TO: St. Francis Planning Commission
FROM: Jason Zimmerman, Consulting Planner
SUBJECT: St. Francis Apartments Concept Review
DATE: 4-10-2025 for 4-16-2025 meeting
APPLICANT: North Shore Development Partners
LOCATION: 3731 Bridge St NW and PID 32-34-24-31-0016
COMP PLAN: Medium Density Residential and Medium/High Density Residential
ZONING: R-2 and R-3

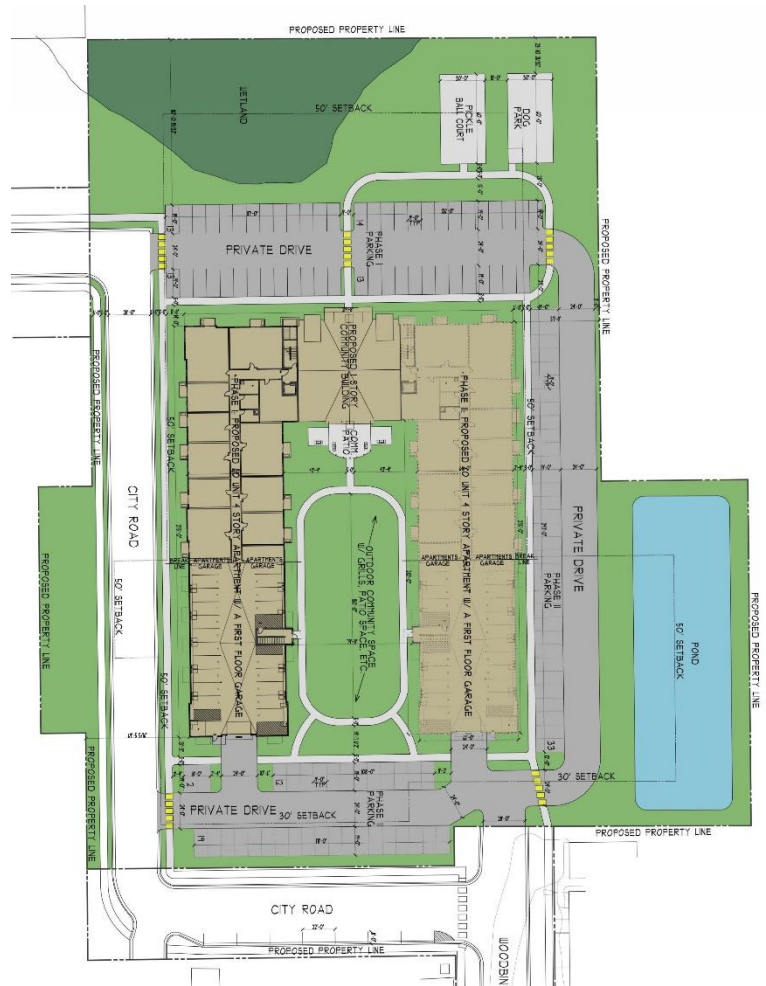
move forward, a Comprehensive Plan Amendment would be needed to reclassify these properties as High Density Residential use (12-20 units per acre). Even with this designation, the proposed density of 120 units on 4.25 acres (28 units per acre) is greater than what is allowed. In order to meet the density requirements, the number of units would need to be reduced to 85, the size of the development would need to be increased to 6 acres, or some combination of the two adjustments would need to be made.

With the inclusion of the new public road, the site would have two front yards (west and south). Each front yard would require a setback of 30 feet. Interior side yard setbacks are 10 feet and the rear yard setback is 25 feet. As shown, the building placement would need to be adjusted in order to meet the front yard setback to the west. A 50 foot setback is required from the R-1 zoned properties to the east; this distance appears to be met.

The applicant is proposing first floor enclosed parking spaces for each phase of construction (total number of spaces unknown) with 52 phase 1 surface lot spaces and 66 phase 2 surface lot spaces (118 total). Required parking for apartment buildings is based on the type of unit (number of bedrooms). Without floor plans, it cannot be determined if the proposed parking meets the City’s requirements. However, at least one space per unit must be enclosed which equates to 120 enclosed parking spaces.

No parking is allowed within 5 feet of a property line. Along the west property line, the parking setback may need to be adjusted.

Sidewalks are shown encircling the building, along the parking lots, and leading to the outdoor amenities. City code requires that sidewalks abutting parking stalls must be 6 feet wide. This dimension should be confirmed as refined plans are prepared.

building divided by 320. Other landscaping standards require a diversity of species. As currently shown, there are long stretches of the parking lot lacking landscaping – parking lot islands with trees should be considered.

Site standards limit impervious coverage to 50% of the area. When the second phase of the building and additional parking lots are constructed, this threshold may be surpassed.
